Our ref: MP06_0258-Mod-15

Subject: Response to Submissions Request

Notification of the proposed modification to the Casuarina Town Centre Concept Plan Development (MP06_0258-Mod-15) concluded on 21 June 2024. During the notification period, the Department received 25 submissions, including one from Council to the proposed modification. The Department also received an agency response from Transport for NSW. The submissions are directly available online:

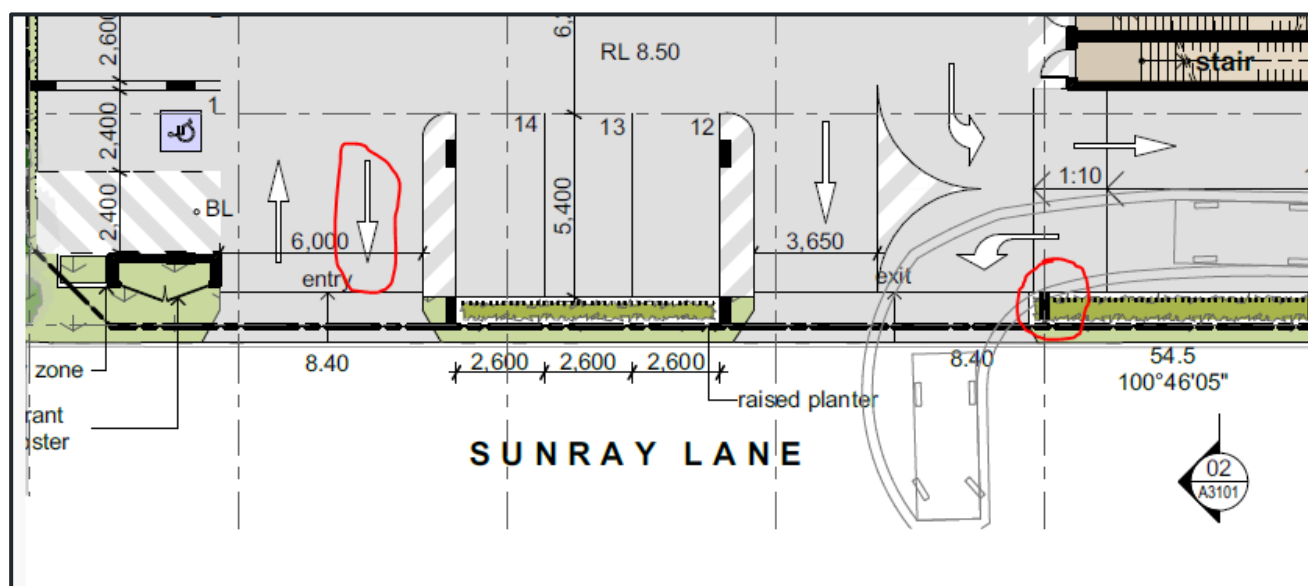
Manoeuvrability of vehicles travelling in, out and within the parking area is unclear. Swept path diagrams are to be provided with the following at a minimum:

- Detail of Sunray Lane in full including the verge and any significant details of the dwellings to the south that may impact on the manoeuvrability of vehicles.
- All possible vehicle movements when entering and exiting from Sunray Lane e.g. left- and right- hand turns from Sunray Lane into the site.
- Access into and out of accessible parking spaces Nos. 1 and 11 and other spaces at corners and junctions.
- Inconsistencies corrected as per below image marked up in red.

Note: All swept paths, including clearances, shall be free of obstruction and not result in any conflict with oncoming traffic.
